Re: NCIRT Review and USACE Approval of the Jacobs Ladder Mitigation Plan (SAW 2012-01007)

SUBJECT: NCIRT Comments During 30-day Mitigation Plan Review

NCEEP Project Name: Jacobs Ladder Stream Mitigation Site (EEP-IMS# 95023), Rowan County, NC

USACE AID#: SAW 2012-01007

DATE: MAY 2012
SCALE: 1"=40'
SITE PLAN & PROFILE
SHEET 11 OF 23

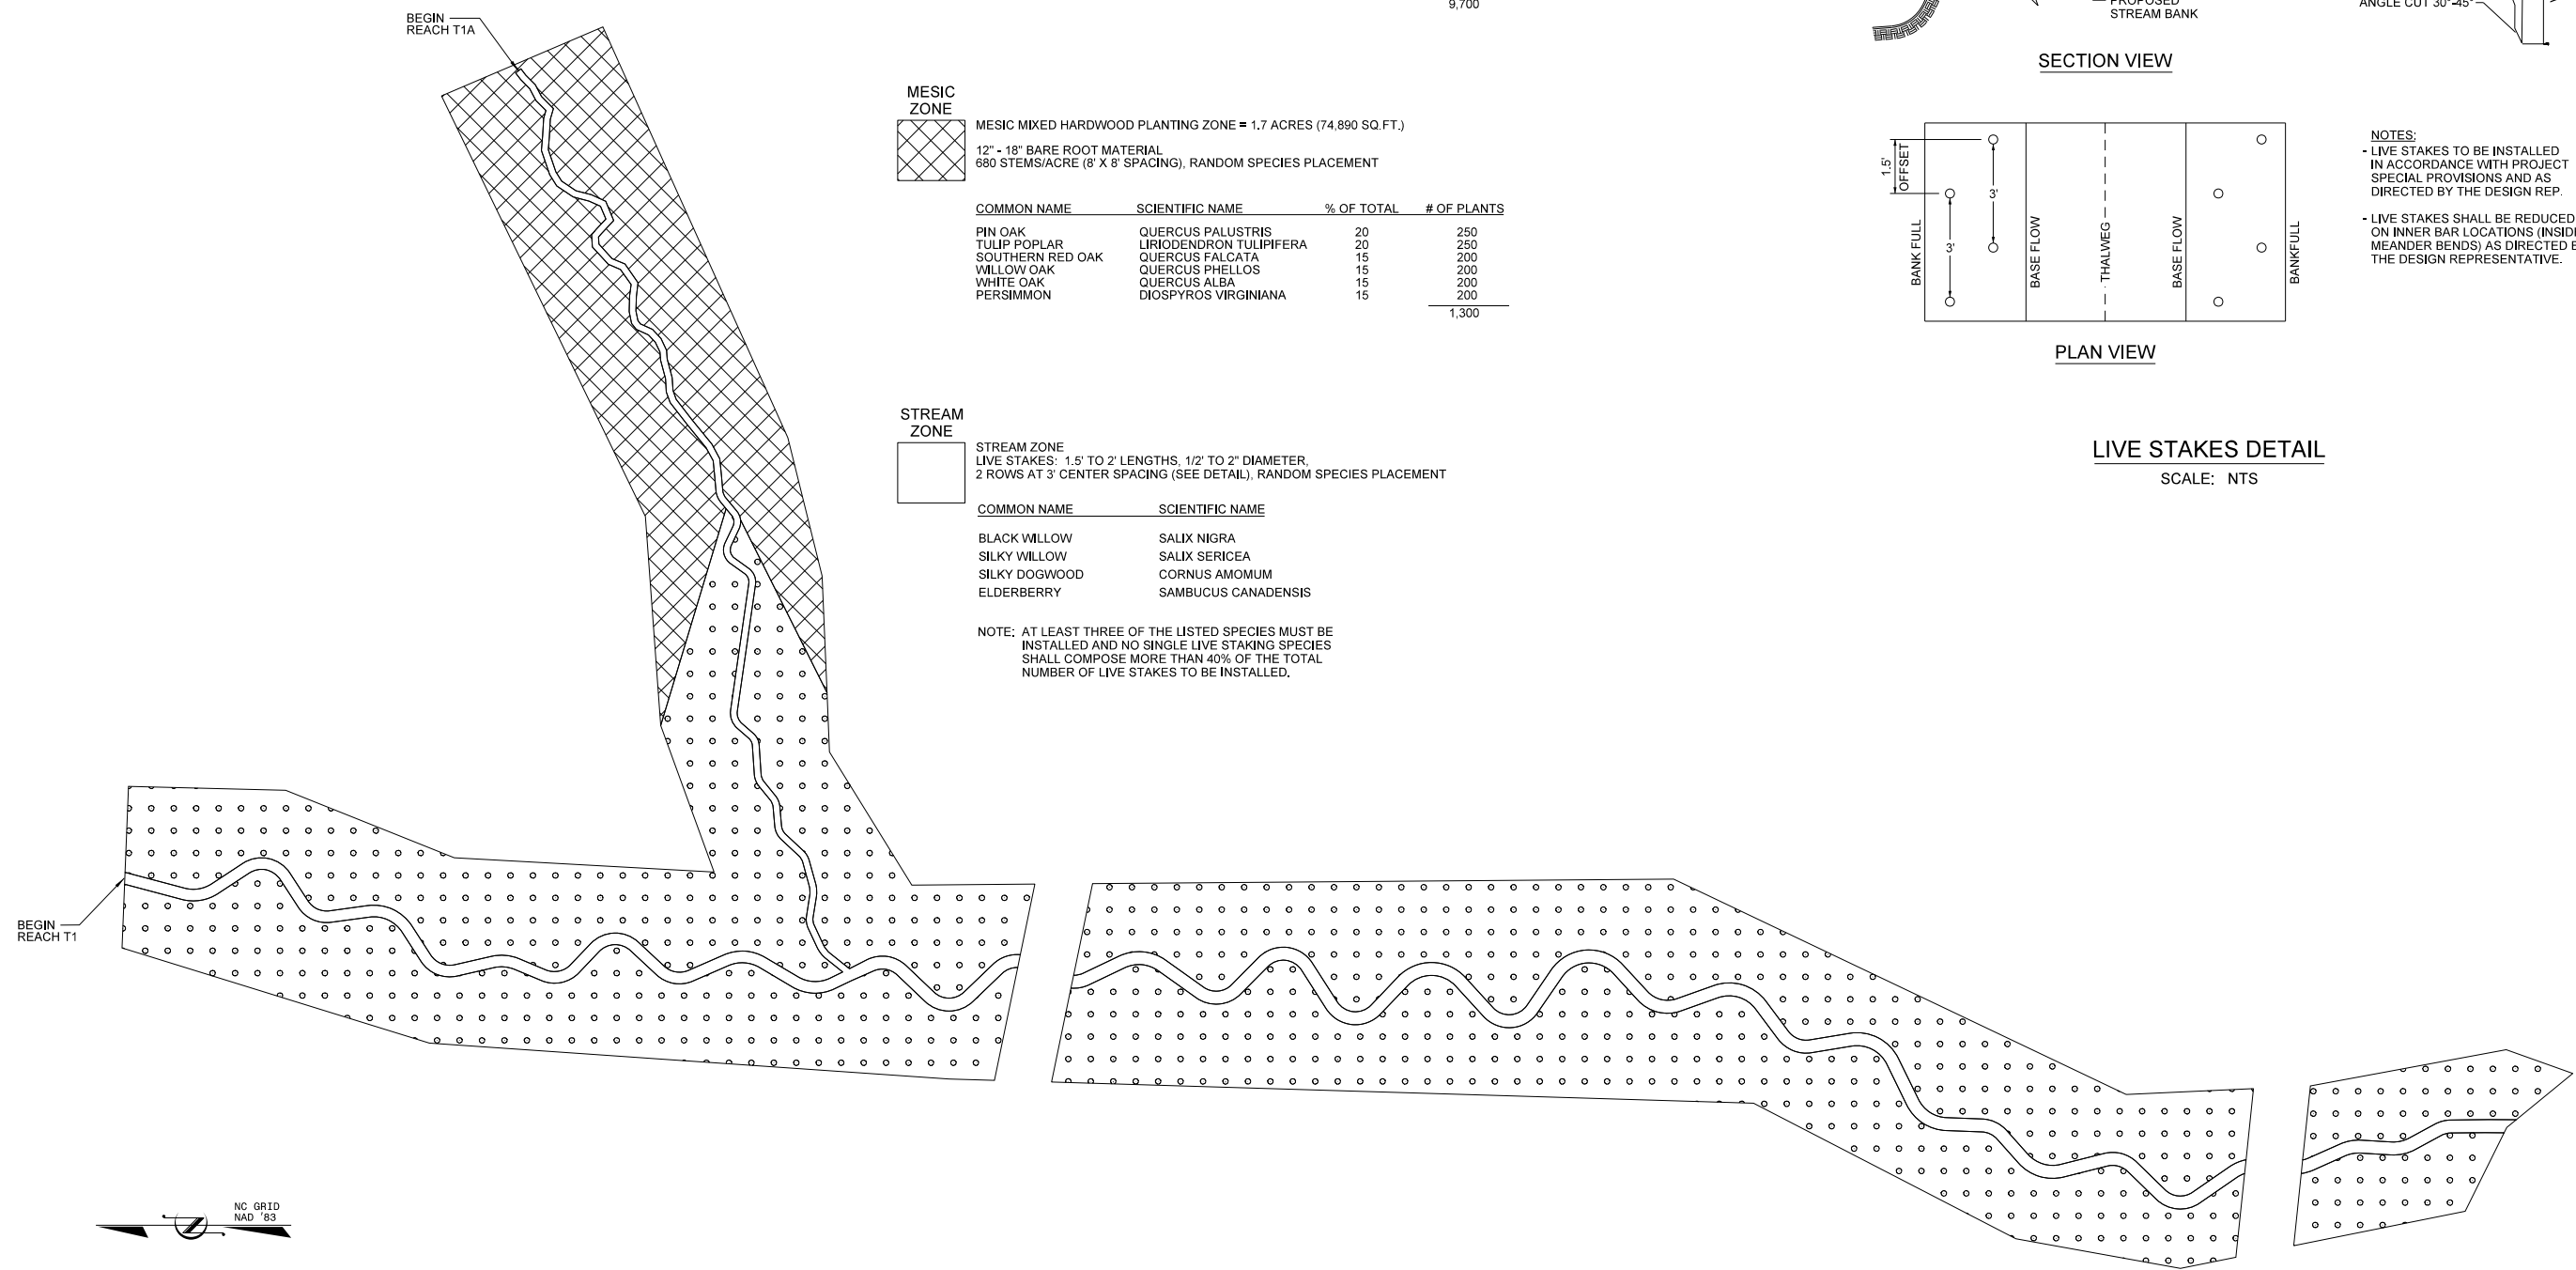
- d. Site Plan and Profile, (sheet 11 of 23), Sta. 119+25: A 50’ crossing is proposed. Please ensure that all crossings on the project are wide enough to allow for future planned uses on the property, including any municipal or DOT mandated road widths, if anticipated.
